October 10, 2013
Project No. 8128.01.20

Re: Fill WBZ Investigation Work Plan and DEQ Comments—Siltronic Corporation
Property

REVIEW OF INVESTIGATION WORK PLAN
FOR FILL WATER-BEARING ZONE
TRENCH FOR SILTRONIC, PORTLAND,
OREGON

Figure 2
Proposed Trench
Alternatives 1 & 2

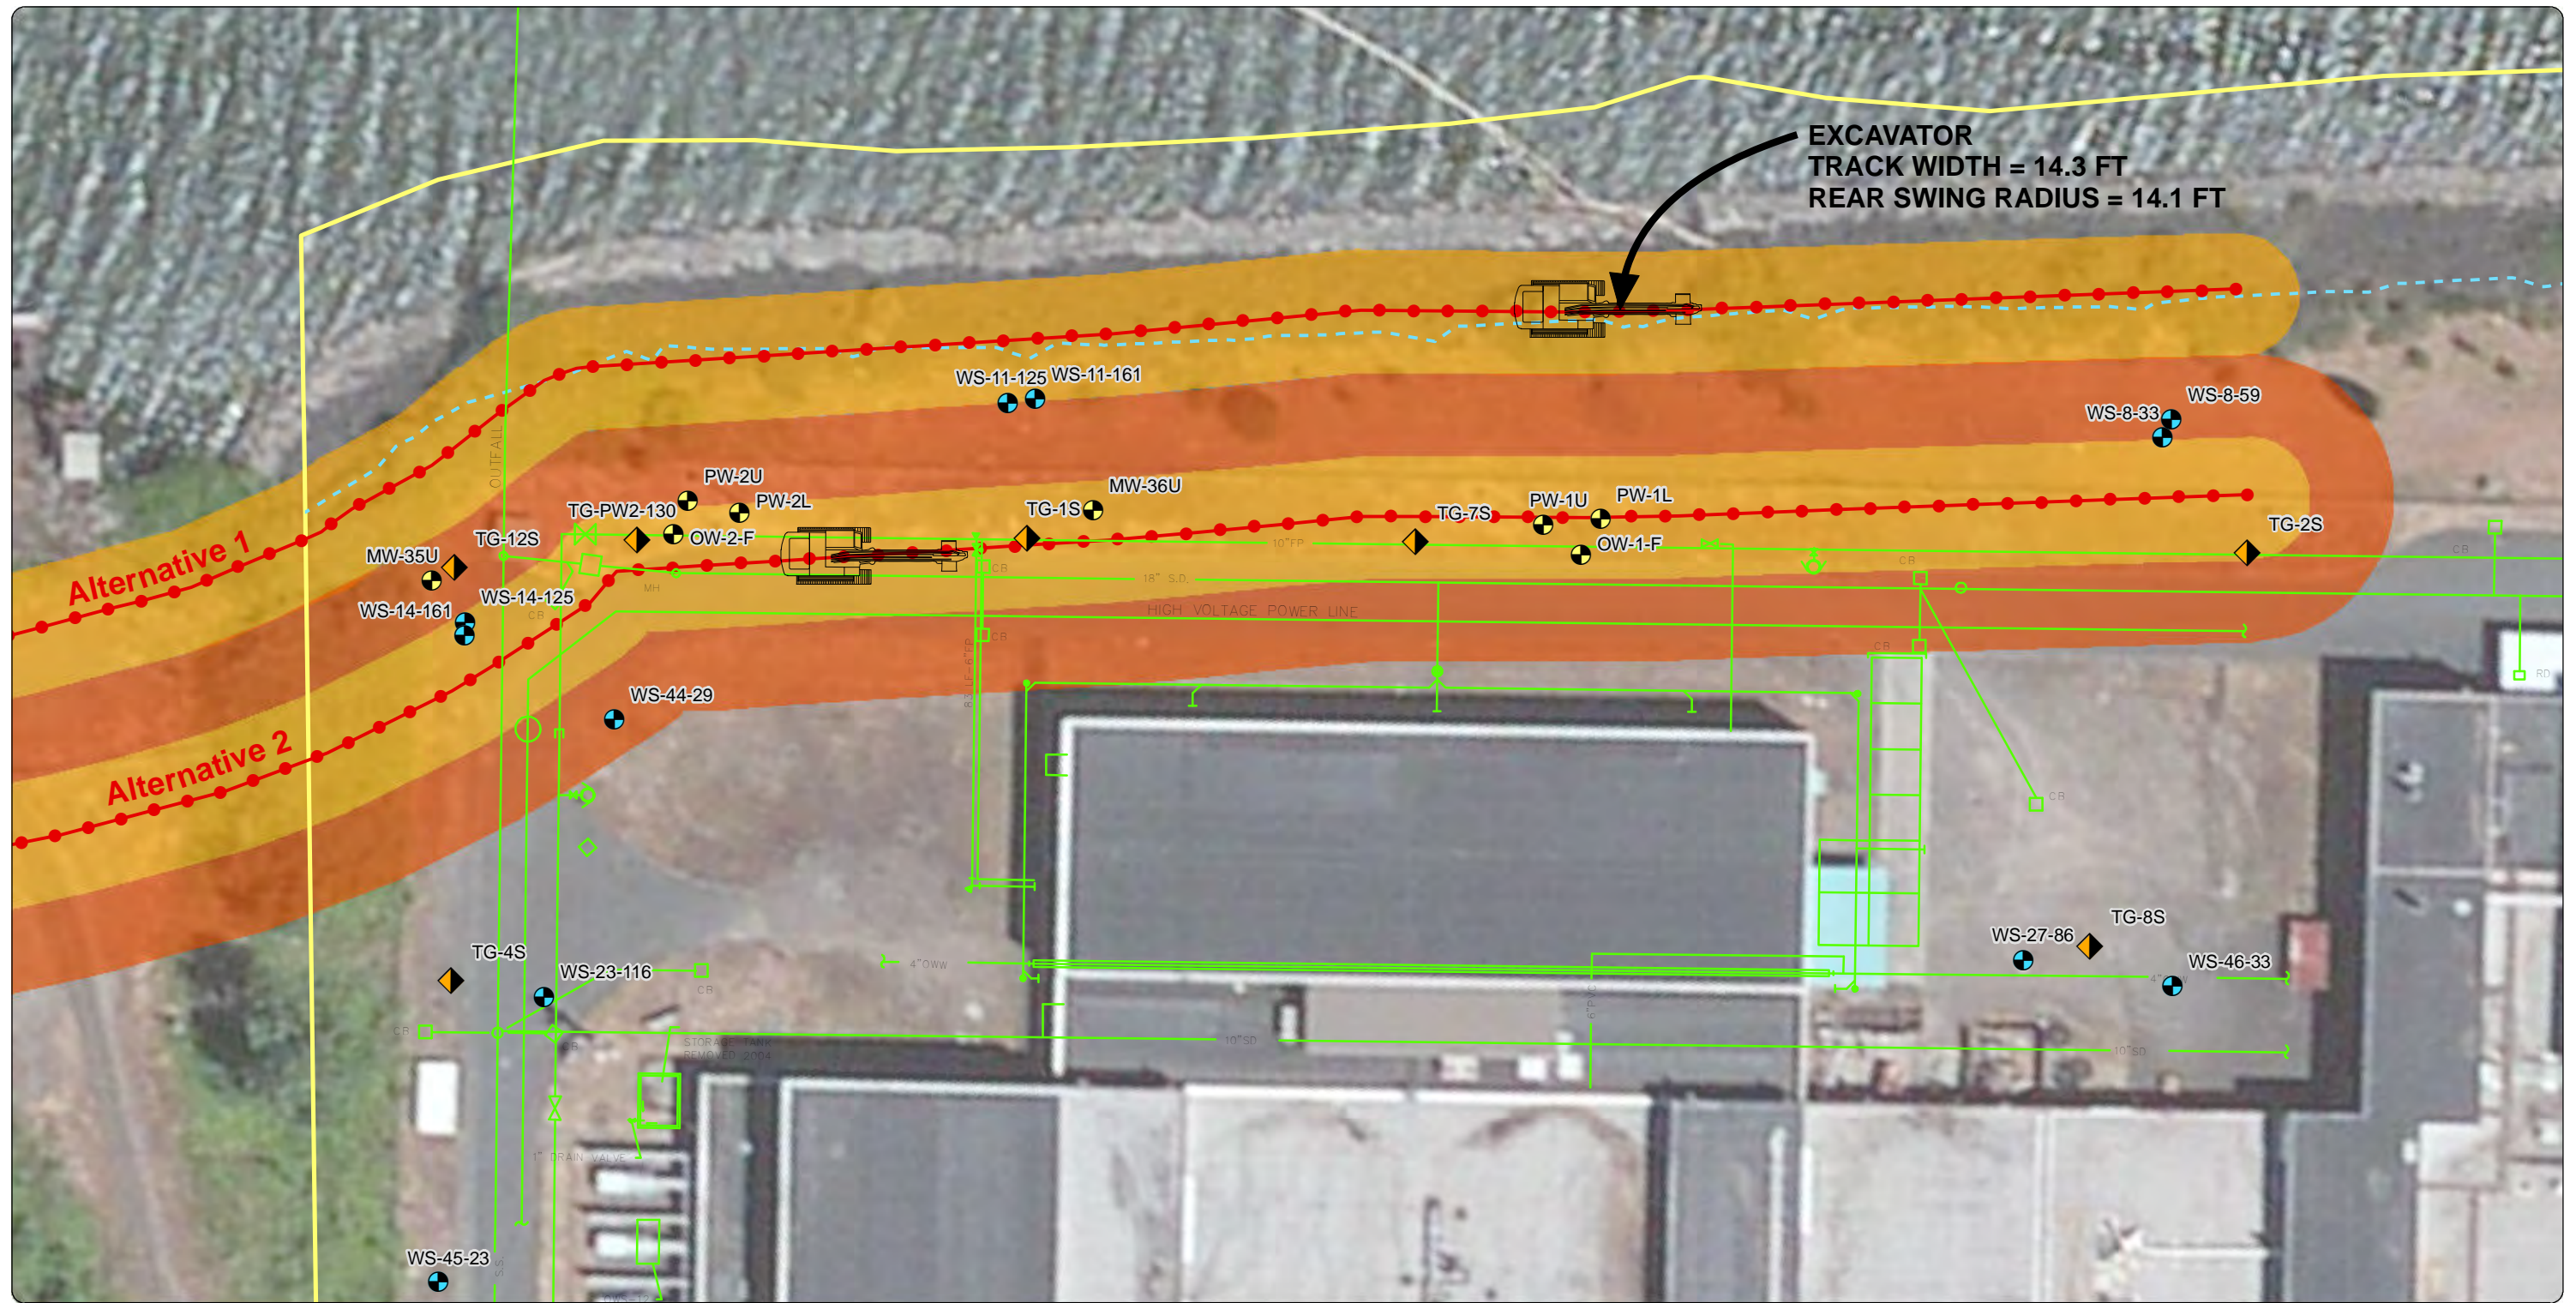
Alignment Location – Both alignments pose significant safety or logistical concerns regarding slope stability, building stability, and the integrity of the alluvial hydraulic control/containment (HC/C) system components. Figure 2 shows the proposed alignments, and illustrates several safety or logistical issues.

- Slope stability concerns are associated with placing the trench at the top of bank location (Alternative 1). Proposed in-water remedial action activities currently include dredging and excavation at the base of the bank slope, the lateral extent of which is yet to be determined and could be adjacent to the IT. Excavation of the slope and sediments at the toe of the slope is anticipated to decrease overall bank stability, especially with the shear plane created by the IT, as noted in the CH2M Hill memorandum. Lack of data regarding the composition and physical properties of the fill material through which the trench would be constructed area also problematic, in that encountering rubble, large debris, or other highly permeable materials during trench construction could cause rapid loss of slurry fluid and result in trench failure.

- Both alignments require clearing access on either side to allow for equipment operation and maintaining minimum safety zones for workers. These are shown as the yellow and orange footprints on Figure 2, and they intersect multiple permanent surface features (such as the HC/C system components).

- The alternative alignment (Alternative 2) proposed adjacent to the Fab 1 building extension does not consider that the IT should be located a minimum distance away from the existing building to avoid impacts to the structure from soil settlement. The primary impact of the trench on surrounding soil (settlement) for a well-constructed and fluid filled trench is anticipated to occur within a horizontal distance equal to the trench depth (approximately 35 feet), or 1:1 horizontal to vertical (H:V). Impacts may be experienced as much as two-times the trench depth, or 2:1 (H:V) for less desirable trench conditions (i.e., unconsolidated fill material)⁴ consistent with site conditions. Utilizing a 2:1 horizontal setback, the IT alignment would be located at least 70 feet from the Fab 1 extension building foundation. Additionally, numerous other structures including the access road, subsurface utilities, and the HC/C system fall within the 2:1 H:V footprint and would need to be protected and avoided, or relocated. Until DEQ or NWN can determine otherwise, Siltronic will require at least a 2:1 setback from existing structures for the purpose of safety and preserving structural integrity.

- These alignments will require removal and replacement of critical infrastructure, including utilities and the HC/C system required for source control. These utilities include, but are not limited to, stormwater collection and conveyance structures, high voltage electrical conduit encased in a concrete vault, a fire protection water system, and alluvial groundwater extraction wells (the HC/C system) and transmission lines.

Access and Work Sequencing – As mentioned above, additional information regarding the types of equipment used to complete the trench construction must be provided to evaluate feasibility with site conditions. For the analysis on Figure 2, MFA has assumed standard excavating equipment and identified operational areas based on equipment specifications. If alternative equipment or methods are proposed to allow for a different alignment alternative, this information should be included and the Design Report should be updated.
